UNITED STATES PATENT AND TRADEMARK OFFICE

APPLICATION NO.	FILING DATE	FIRST NAMED INVENTOR	ATTORNEY DOCKET NO.	CONFIRMATION NO.
09/940,792	08/29/2001	Paul A. Farrar	M4065.0382/P382-A	5268
24998	7590	06/13/2005	EXAMINER	
DICKSTEIN SHAPIRO MORIN & OSHINSKY LLP			LEE, EUGENE	
2101 L Street, NW			ART UNIT	
Washington, DC 20037			PAPER NUMBER	
			2815

Office Action Summary

DETAILED ACTION

FIG. 47

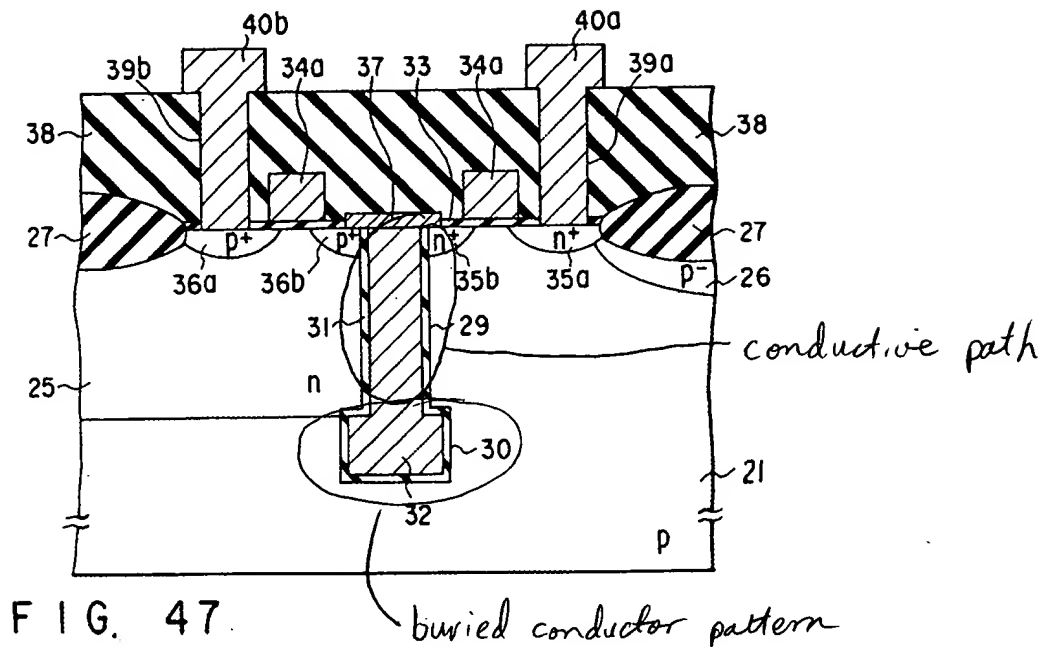
Yamamoto discloses (see, for example, FIG. 47) an integrated circuit substrate comprising a substrate 21, and bottom rectangular-shaped wiring layer (buried conductor pattern) 32. The bottom rectangular-shaped wiring layer is completely surrounded by the substrate, and forms an interconnect between MOS transistor (devices) 34a. A conductive path from the bottom rectangular-shaped wiring layer extends to said MOS transistors. A portion of the conductive path extends below a top surface of said substrate.

Regarding claim 56, Yamamoto discloses (see, for example, FIG. 47) an integrated circuit substrate comprising a substrate 21, and bottom rectangular-shaped wiring layer (at least one empty-spaced pattern) 32. The bottom rectangular-shaped wiring layer is completely surrounded by the substrate, and connects forms an interconnect between MOS transistor (devices) 34a. A conductive path from the bottom

Regarding claim 58, see, for example, FIG. 47 wherein Yamamoto clearly discloses the bottom rectangular shaped wiring layer 32 having a pipe-shaped/plate-shaped configuration.

Regarding the limitation "said conductive structure" in line 11 of said claim, see, for example, FIG. 47 wherein Yamamoto clearly discloses the bottom rectangular shaped wiring layer (conductive structure) 32.

Regarding claims 63, and 64, see, for example, FIG. 47 wherein Yamamoto clearly discloses the bottom rectangular shaped wiring layer 32 having a pipe-shaped/plate-shaped configuration.
